ORIGINATION FORM

Proposed Revisions to a Standard Plans Index
(Please provide all information — Incomplete forms will be returned)

Index Number: 425-061
Sheet Number (s): 2
Index Title: Closed Flume Inlet

LAST REVISION 11/01/20	DESCRIPTION:	FDOT	FY 2021-22 STANDARD PLANS	CLOSED FLUME INLET	INDEX 425-061	SHEET 2 of 5
---------------------------	--------------	------	------------------------------	--------------------	------------------	-----------------

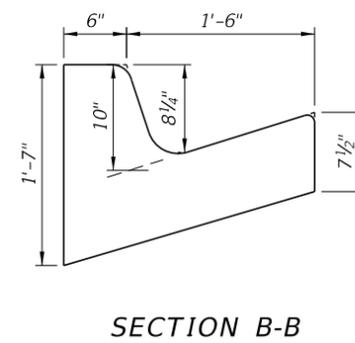
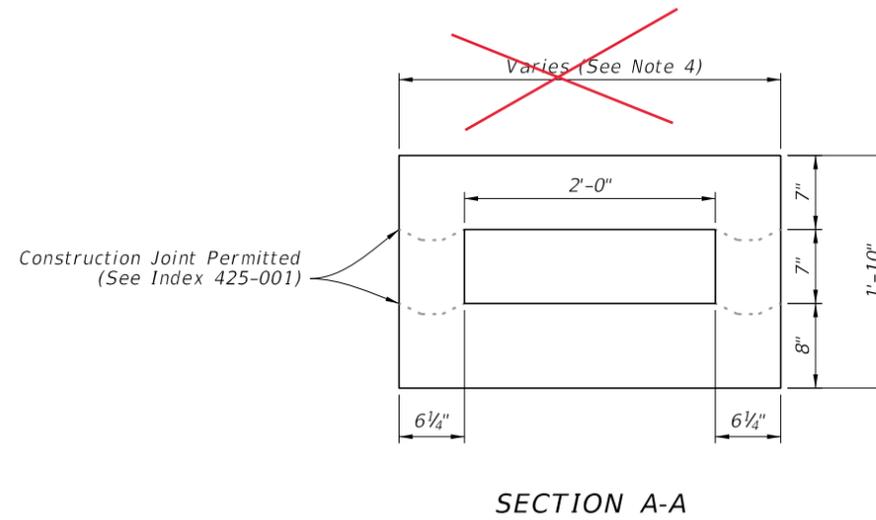
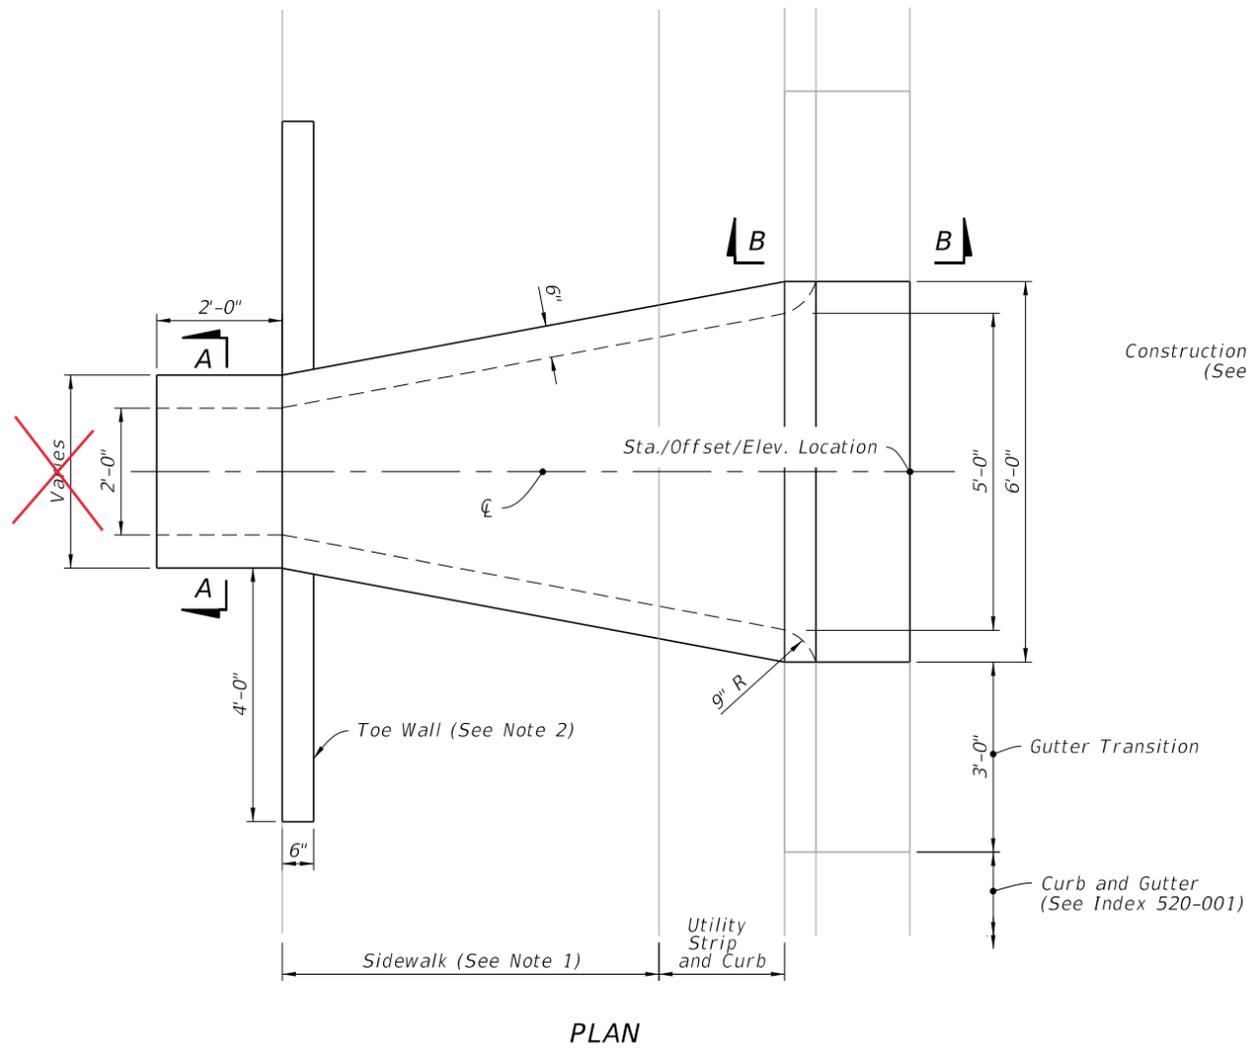
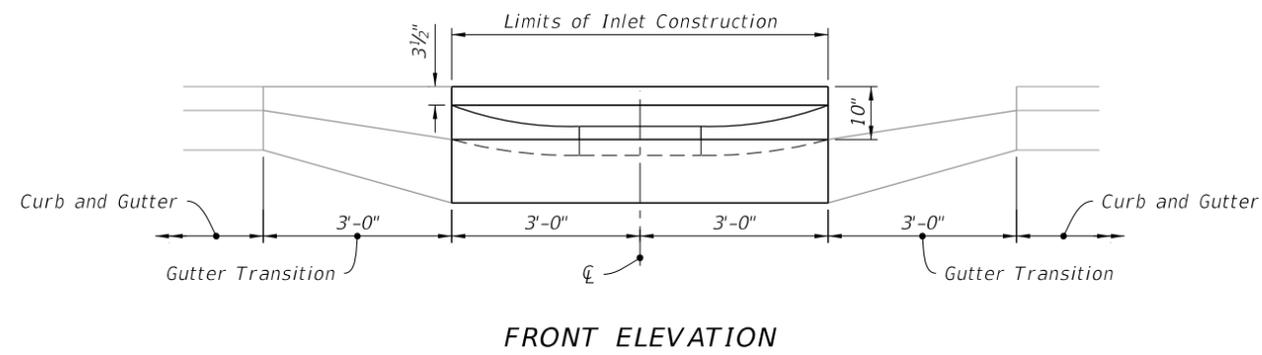
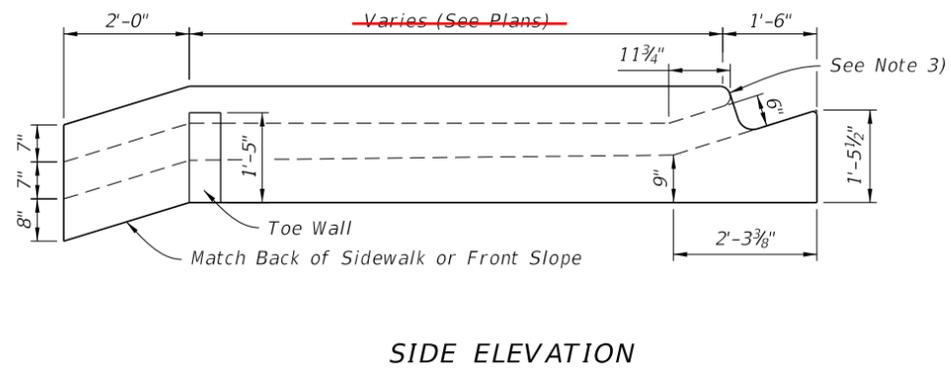
Revised dimension in Side Elevation detail to "Flume Length Varies (See Plans)". This also requires a change to the SPI. Deleted "Varies from 3' 1/2" to 6'-0" for single barrel flume." from note 4. Deleted "varies" from section A-A and Plan view.

Remove reference to Dimension "D" in SPI and change text in SPI and Index to "Flume Length" to allow for this to be called for in the Plans. The "varies" callouts were deleted from the section references and note because the sections as shown are not variable.

- NOTES:**
1. Use sloped section with sidewalk applications only.
 2. Use Toe Walls with Sidewalk application only. For Endwall without Sidewalk see DETAILS on Sheet 4.
 3. Slope to match adjacent curb with 2" top radius and 1 1/4" bottom radius.
 4. ~~Varies from 3'-1/2" to 6'-0" for single barrel flume. See Sheet 5 for multiple barrel flumes span variation.~~

CHANGED TO: Flume Length Varies (See Plans)
